ENGINE INDICATING - REPLACEMENT OF EGT LOOP CLAMP BRACKETS AND ATTACHING BOLTS -
CATEGORY CODE 3 - MOD.ENG-77-0002

V2500-ENG-77-0002

Replacement of EGT loop clamp brackets and attaching bolts
Fig.1 Sheet 1 of 2

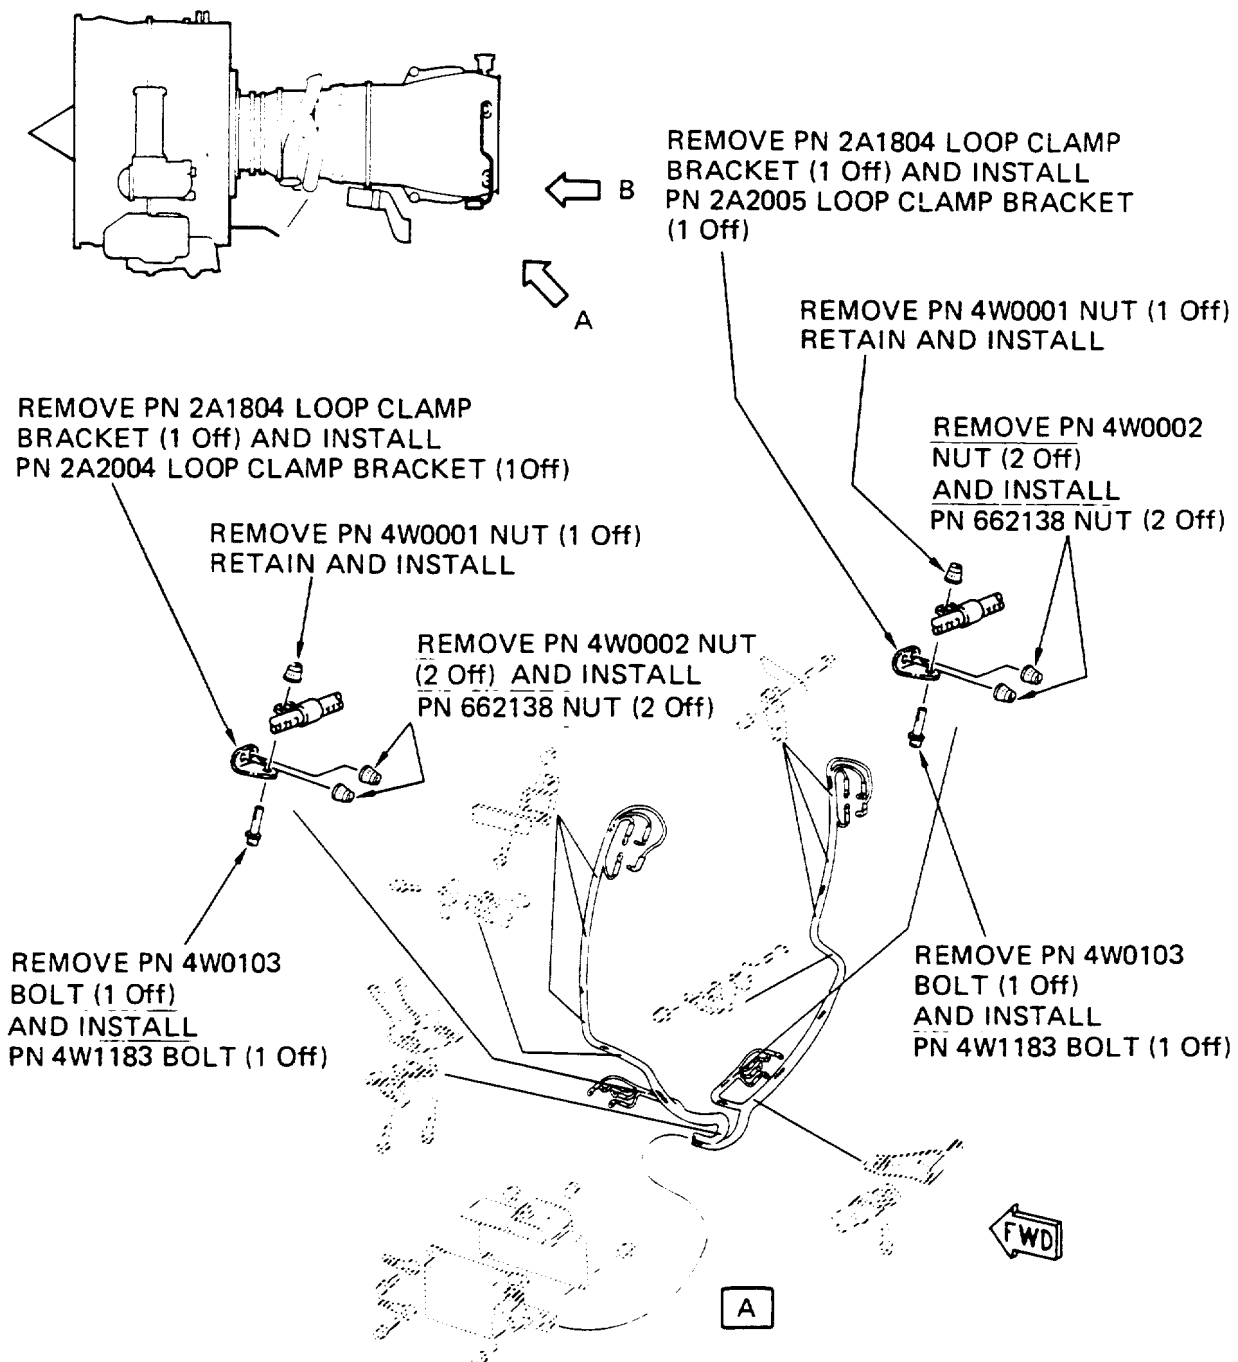
The present configuration EGT Brackets on flange P at hole location 52, 53, 62 and 63 can physically interfere with the Hold Open Rod Brackets for the C-Ducts.

(1) Interference between the EGT Brackets (at P Flange hole locations 52, 53, 62 and 63) and Hold Open Rod Brackets for the C-Ducts is removed as follows:

(a) Two new brackets are provided to attach the Harness at the locations specified.

(b) New bolts are provided to attach the Loop Clamps to the Loop Clamp Brackets.

- (1) Remove the Nuts and Bolts which hold the two 2A1804 loop clamp brackets to the Loop Clamps. Refer to Figure 1.

- (2) Remove the Nuts and Bolts which hold the 2A1804 Loop Clamp Brackets to the Turbine Exhaust Case Flange. (Hole Locations 52, 53, 62 and 63).

- (5) Put the 2A2004 Loop Clamp Bracket (1 off) at the location of holes 62 and 63. Refer to Figure 1.

- (7) Put the 2A2005 Loop clamp Bracket (1 off) at the location of holes 52 and 53. Refer to Figure 1.

- (9) Torque the Bolts to between 85 to 105 lbfin (9,60 to 11,86 Nm). See Reference (2) Chapter/Section 70-41-00, Torque Tightening Technique.
